MAY 2023

VICTORIAN PLANNING AUTHORITY

## SODIC/DISPERSIVE SOILS PEER REVIEW AND ASSESSMENT MERRIMU PRECINCT

## Sodic/Dispersive Soils Peer Review and Assessment Merrimu Precinct

Figure 5.1 Proposed test pits locations (Coffey, 2020a)

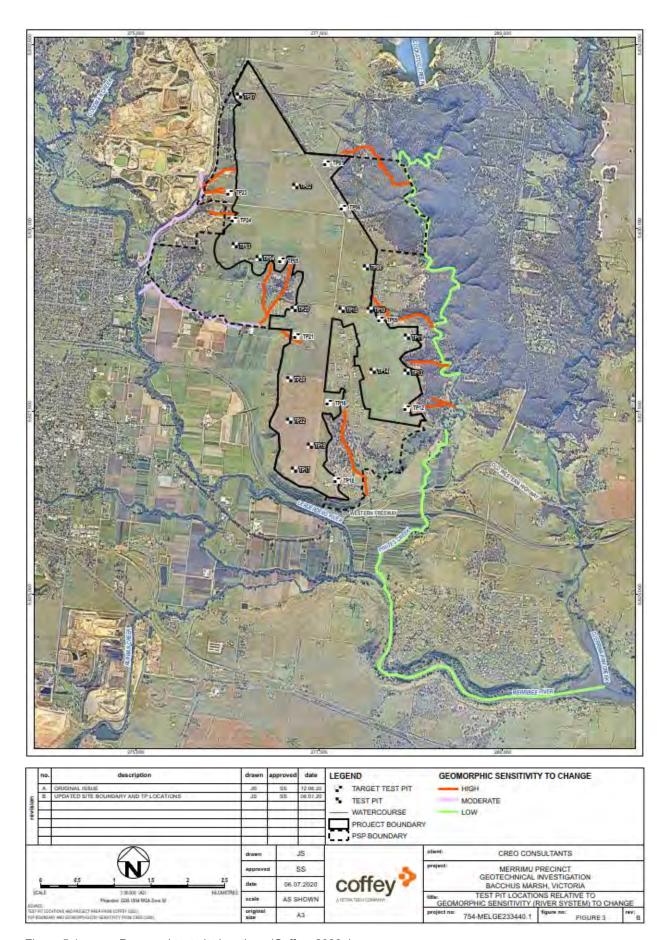
The methodology for the field investigation in Coffey's Soil Sodicity and Dispersiveness Assessment (see Section 5.1.6 below) was outlined and justified in the desktop assessment. It mentions that the test pits for the assessment were targeting mainly the geomorphologically sensitive areas around the escarpment and near waterways close to the development area boundaries (labelled Target Test Pit). Additional test pits outside the sensitive areas were planned to assess the general subsurface conditions across the site (labelled Test Pit). No test pits were proposed further down towards the bottom of the escarpment or in the flood plains. The Coffey (2020a) proposed test pit locations are shown in Figure 5.1 (following page).

In summary, Coffey (2020a) used various references, in particular the Geomorphology and Vegetation Assessment by Alluvium (2019), to inform their proposal to undertake a soil sodicity and dispersiveness assessment. The regional geology, soil sodicity and dispersiveness, and geomorphological and vegetation information for the precinct was collated and an investigation methodology was devised.

Figure 5.4 Study Area, extracted from Coffey (2020c)

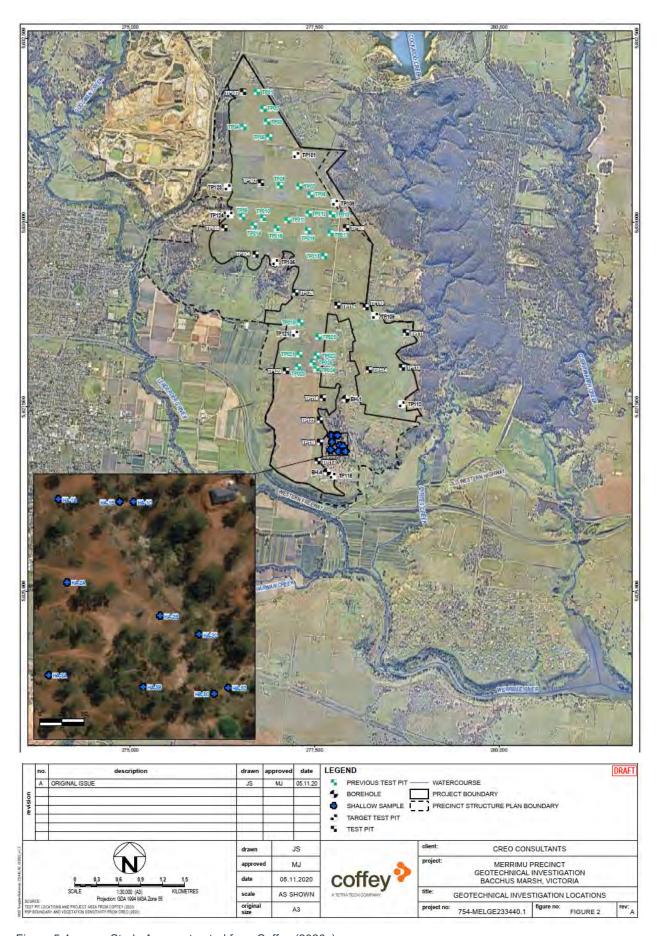
The Soil Sodicity and Dispersiveness Assessment followed the desktop assessment and aimed to sample the soils within the Merrimu PSP site. The objective of the work was to inform the VPA of the dispersity of the soils and to provide recommendations for mitigating or preventing erosion. The assessment also provided comments on the subsurface and groundwater conditions at the site, depth to and thickness of the Werribee Formation, and geotechnical considerations such as excavatability, and suitability of excavated material for re-use as engineered fill.

Two field investigations were undertaken by Coffey for the purposes of the assessment, with one investigation occurring between the 4<sup>th</sup> and 6<sup>th</sup> August 2020 involving 25 test pits, and the second occurring between the 5<sup>th</sup> and 7<sup>th</sup> October 2020 involving 2 additional boreholes and 10 shallow sample locations. Both investigations included collection and analysis of selected soil samples for exchangeable sodium percent (ESP) and Emerson soil crumb test. Additionally, the August 2020 investigation included Pinhole Dispersion testing; a technique to provide a qualitative measurement of the dispersibility and consequent erodibility of clay soils.

Figure 5.6 Location of possible discharge options with recommendations

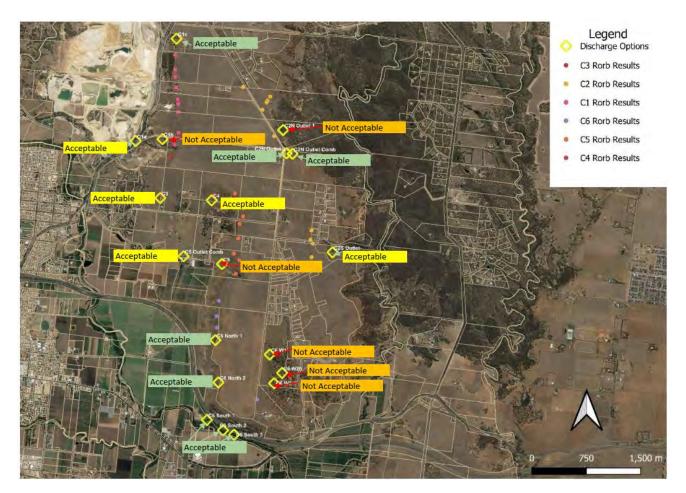
Considering the three 'Not Acceptable' discharge locations in the southern section of the precinct (C6 W1, C6 W2b, C6 W2) all three were assessed as having disturbed sodic subsoils. It was determined that more frequent discharges would result in episodic erosion and increased sedimentation in downstream waterways. The discharge option in the centre of the precinct (C5) was deemed 'Not Acceptable' due to the observed erosional nature of the soils. Furthermore, terraced slope was present which appeared to have been undertaken to mitigate erosional processes. The northwest discharge option categorised as 'Not Acceptable' (C1b) was located within highly sodic dispersive soils within the Werribee Formation. Lastly the 'Not Acceptable' discharge option in the northeast corner of the precinct had a waterway comprising of a steep, incised gully with a cobble bed. It was concluded that discharges from the plateau would increase the incision processes which would widen the gully leading to a high potential of tree falls. Thus, this option was not recommended for discharge of water from the plateau.
